66105A-09

S E R V I C E N O T E

66105A DC Power Supply

The instrument will not communicate or will not complete self test.

Figure1

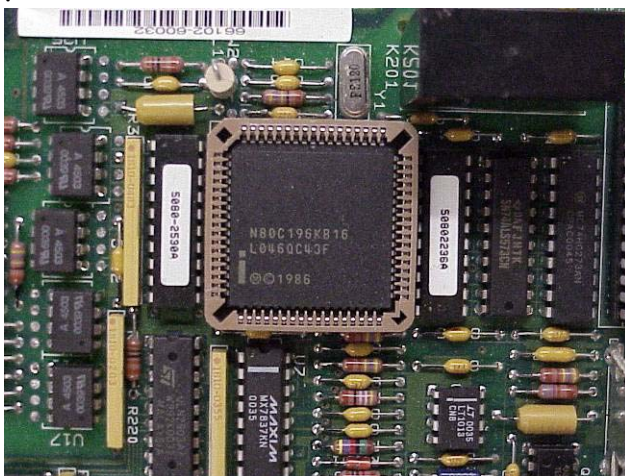
Figure 1 will help to identify the **68-PIN PLCC SOCKET location** - P/N 1200-1274 (Circuit Reference “U001”)

Figure 2

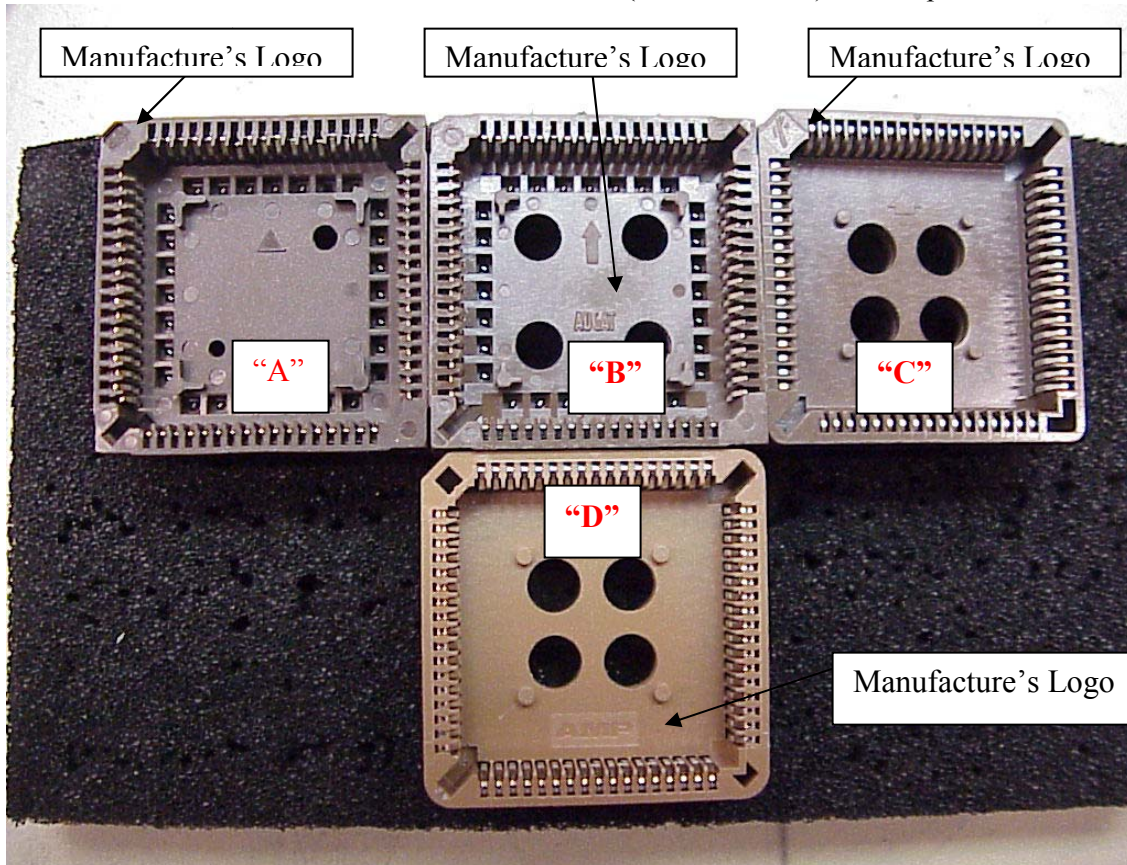
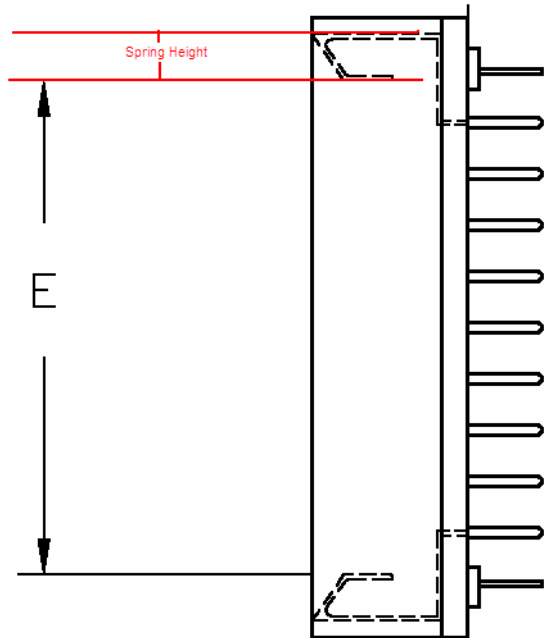
This figure should be used to identify **GOOD** sockets and a potential defective socket. The **16-Bit MCU 16 MHZ 68PLCC CMOS IC** (P/N 1821-1479) is **NOT** pictured.

The following information will help identify each socket type and manufacturer. The manufacturer's logo can be identified as shown. After the **16-Bit MCU 16 MHZ 68PLCC CMOS IC** has been removed there are also mold markings that can be easily viewed these markings should be used to identify a **Good or Defective socket**.

- Socket **"A"** is a sample of a GOOD AMP socket.
- Socket **"B"** is a sample of a GOOD Tyco/Augit socket.
- Socket **"C"** is a sample of a GOOD FCI socket.
- Socket **"D"** is a sample of a DEFECTIVE Tyco socket.

The sockets above labeled **"A", "B" or "C"** are good and should NOT be replaced.
The socket above labeled **"D"** is considered defective should be replaced.

Any Model having a serial number starting and ending with the serial numbers shown in the chart below should have the socket 68-PIN PLCC SOCKET - P/N 1200-1274 (Circuit Reference "U001") **REPLACED!**

Discipline B – Verification of Corrective Action “The socket shown in the pictures are for reference ONLY”

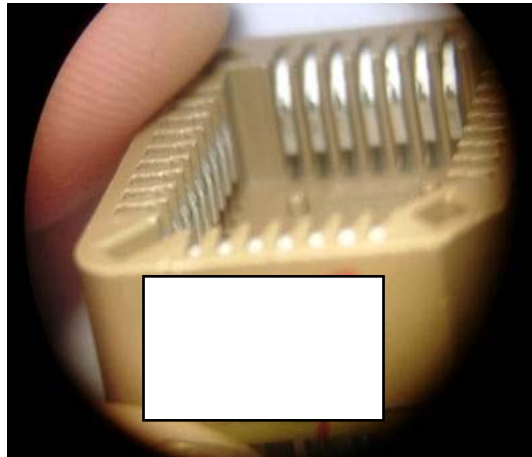
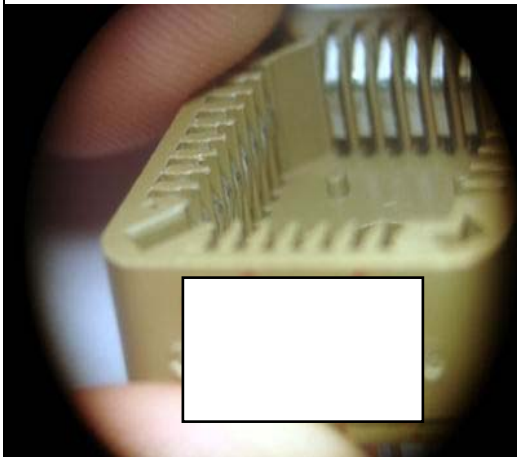
The condition of the recessed beams has been corrected by a design enhancement implemented in production. This design enhancement increased the spring height dimension by 0.04mm and decreased the spring height tolerance by 40%. The spring height dimension is shown in the drawing below.

This design enhancement is intended to position the contact beams closer to the middle of the socket and increase the normal force exerted on the contacts of the chips mated to the socket.

The effectiveness of this design enhancement was tested by comparing the mating and un-mating forces on the older and newer designs. The test results for sockets with the increased spring height (newer design) showed an increase in the mean mating force of 18.9% and an increase in the mean un-mating force of 23.4%. The increase in the un-mating force test results between the old design and the new design indicate that a greater normal force is being exerted on the test chip contacts by the socket contact beams. The two revisions of this contact beam design were visually examined after the mating and un-mating force testing. Photos of the two sockets are shown below. The photo on the left shows the older version socket prior to the enhanced contact beam design. The photo on the right shows a socket with the design enhancement. The contacts with the older design appear to be recessed farther into the housing after un-mating.
